No. **96-1**

Date : October 23, 1995

**SUBJECT : Fuel Tank Cap**

1. Correct fuel tank cap

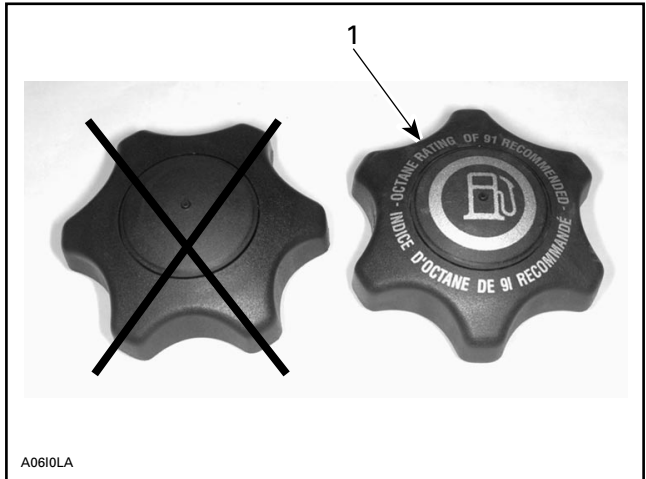
The vehicle has a fuel tank cap without the minimum specified fuel octane requirement on it.

Replace the fuel tank cap.

**INNER RIGHT SIDE OF HOOD**

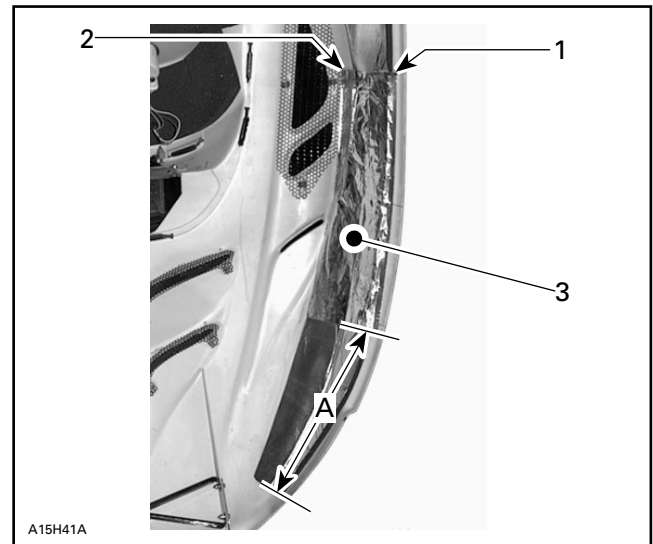
Should the hood louvers become blocked with snow the acoustic foam on inner right side of hood and surface on bottom pan in front of muffler may melt and cause damage.

The decal should overlap the foam surface by approximately 12 mm (1/2 in) on the inner side of the hood.

Measure 330 mm (13 in) from the front edge of the existing acoustic foam.

Remove backing paper from decal then apply to cleaned surface.

1. Muffler support
2. Aluminum grommet
3. Tuned pipe

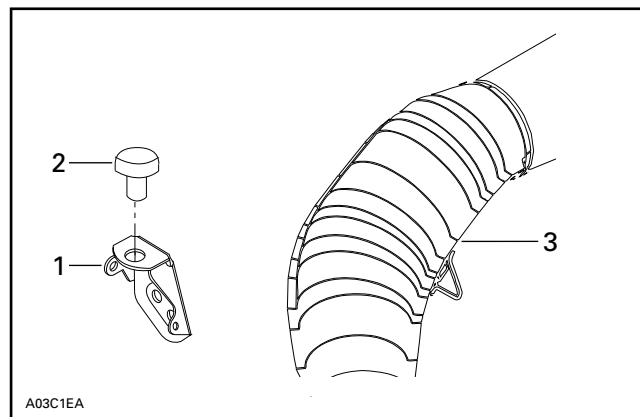
Rubber exhaust grommet on muffler support may melt due to high heat and vibration.

Replace existing rubber grommet with new aluminum grommet, P / N 514 0482 00.

Install new aluminum grommet.

1. Cut here  
A. 6 mm (1/4 in)

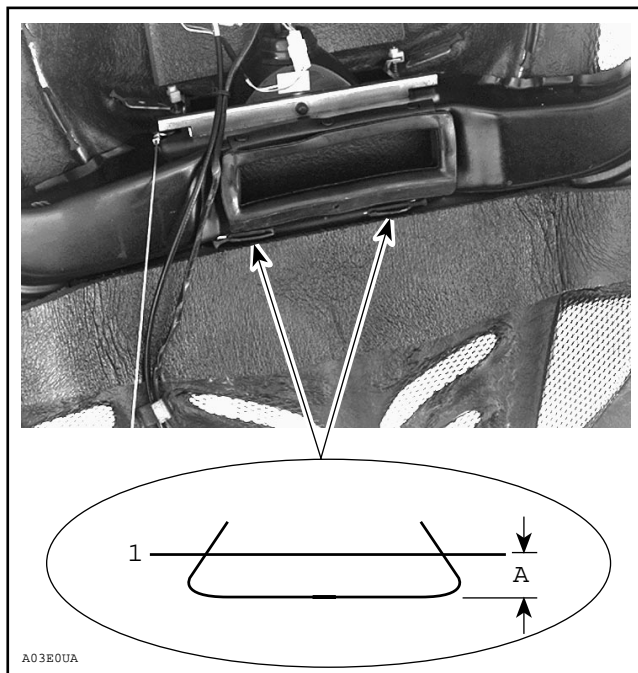
Tabs for headlight trim may interfere with spark plug boots.

Cut the 2 center tabs of the headlight trim.

Mark and cut 6 mm (1/4 in) off of the two center tabs. Remove any sharp corners by rounding off the edges. Refer to the following illustration.

**RIGHT SIDE SHOWN**

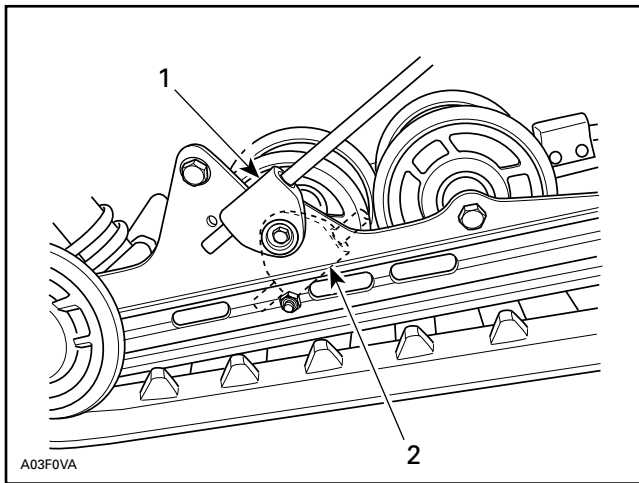
Upper idler wheels on the above mentioned models may freeze and wear prematurely.

Replace worn idler wheels (144 mm dia.) with new rubber coated idler wheels (155 mm dia.).

▼ **CAUTION** : To avoid track damage, spring support must be mounted upward.

1. Clutch Wheel  
2. Sprocket 29 T

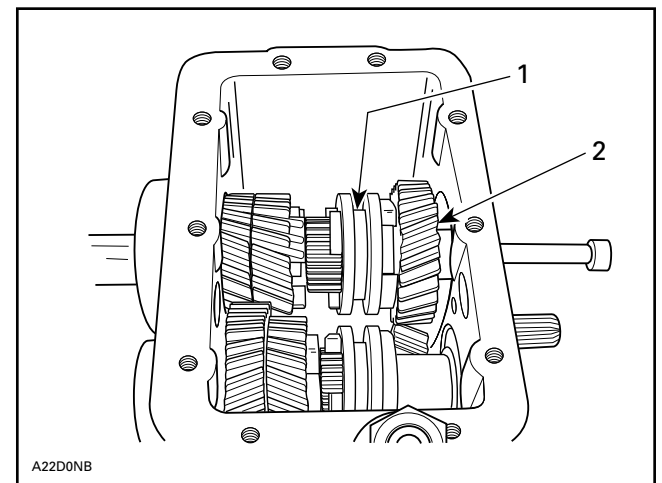
On the above mentioned models, the transmission may shift to neutral while driving.

Remove clutch wheel and 29 T sprocket and replace with new ones.

**NEW LOCATION**

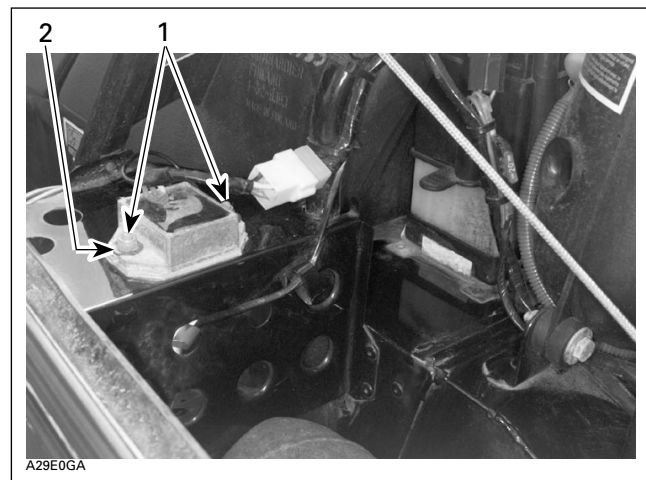
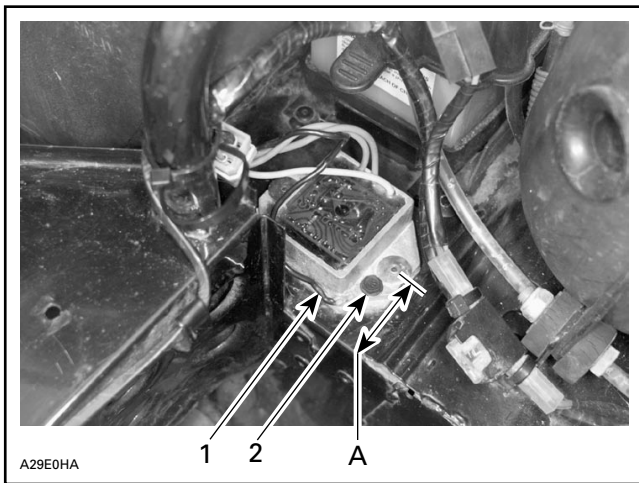
The heat generated by the muffler and/or short circuit at tail lamp may cause damage to the internal circuits of the voltage regulator.

Remove voltage regulator and reinstall on the right side of the front member between footrest and battery.

Using the plate, locate and mark location of the 2 new holes on the front member. Refer to the following illustration for proper location.

Drill two (2) 4.2mm (.166 in) holes using #19 drill. Apply dielectric grease (P/N 413 7017 00) between front member, plate and voltage regulator. Install plate, voltage regulator and secure with rivets.

1. Brake line

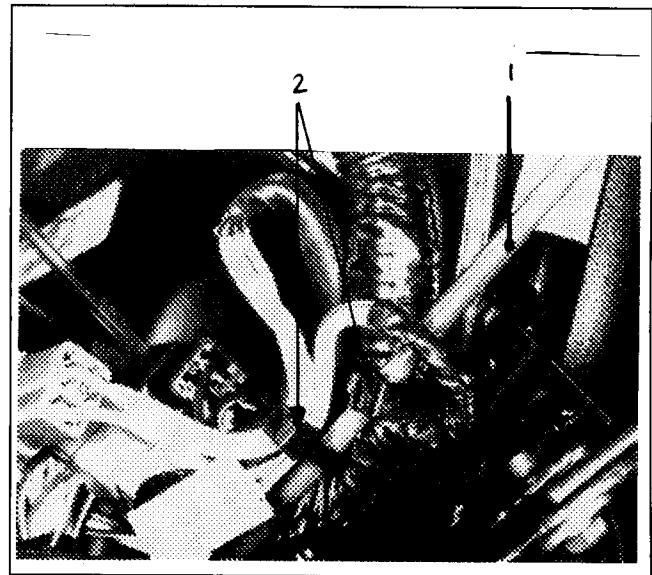
Rust accumulation in solid hydraulic brake line.

Refer to the attached list of vehicle serial numbers. Remove solid hydraulic brake line/hose and brake caliper assembly, replace with new parts.
